Request for Official Interpretation

Figure 12.5.2 HVAC systems map

IC 90.1-2022-13

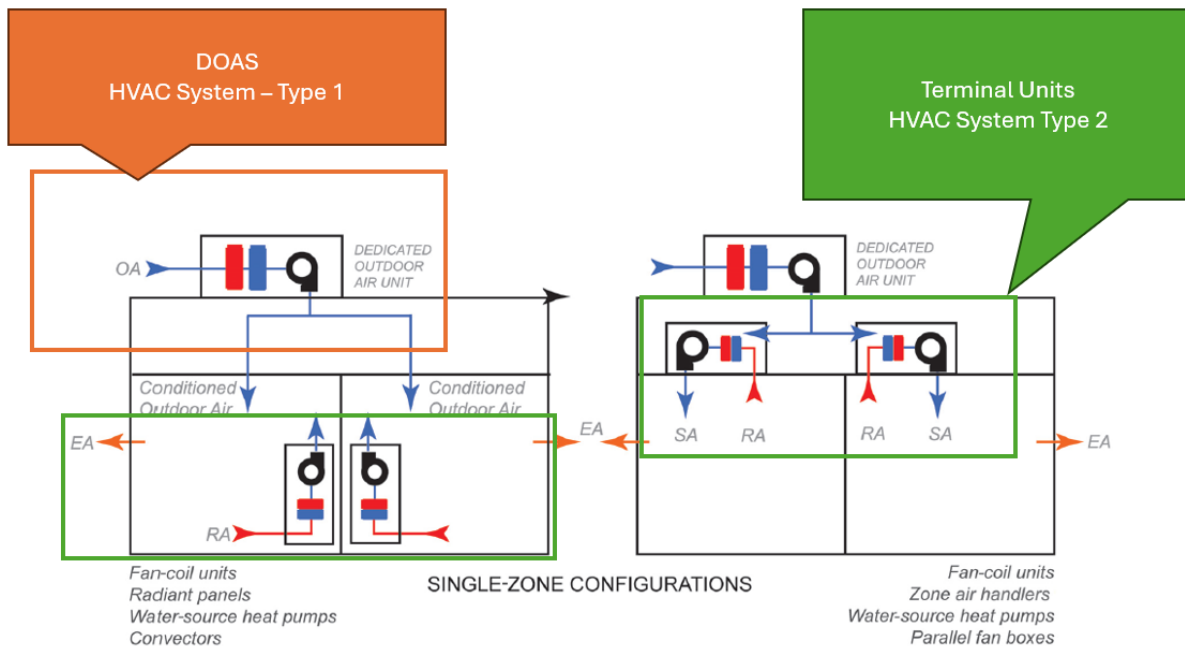
DOAS + terminal-unit systems fall under Section 12.5.2(a):

“Budget Building Systems Not Listed. Components and parameters not listed in Figure 12.5.2 and Table 12.5.2-1 or otherwise specifically addressed in this subsection shall be identical to those in the proposed design.”

- The budget model uses the same system types as the proposed design.
- Equipment and component efficiencies are adjusted to the minimum mandatory and prescriptive levels in Sections 6.4 and 6.5.

No

The DOAS falls under Section 12.5.2(a) but the non-DOAS system providing heating and cooling does not.

- The budget model shall have DOAS of the same type and configuration as the DOAS in the proposed design.
- DOAS equipment and component efficiencies are adjusted to the minimum mandatory and prescriptive levels in Sections 6.4 and 6.5.

- The space conditioning equipment, other than the DOAS, serving zones that are also served by the DOAS shall be mapped using Section 12.5.2(j) and modeled following the requirements in Section 12.5.2.

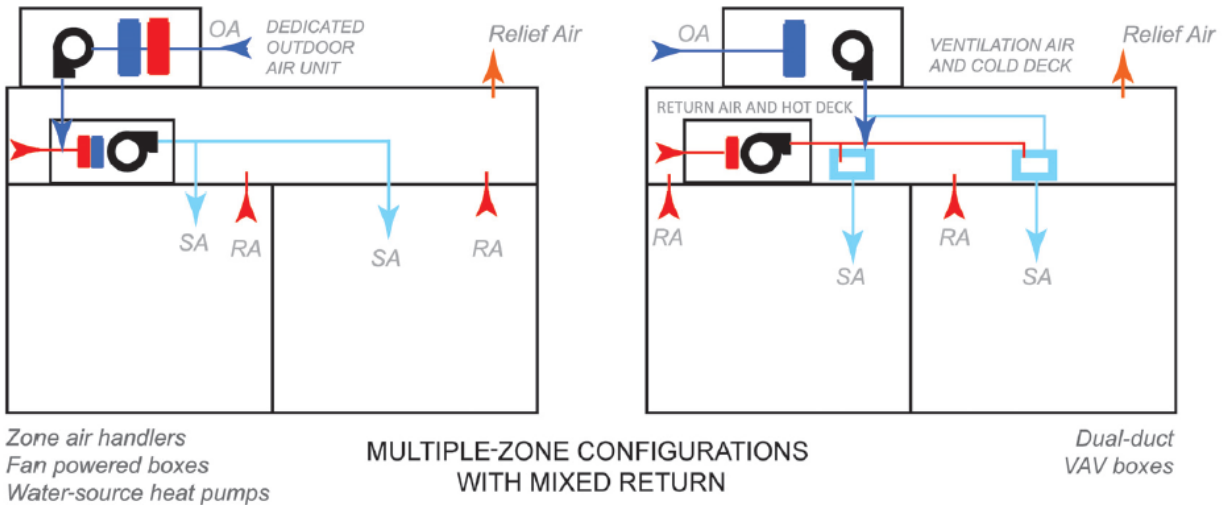
The following are excerpts from the Advanced Energy Design Guideline by ASHRAE to illustrate the variety of potential DOAS plus terminal air handling system arrangements.
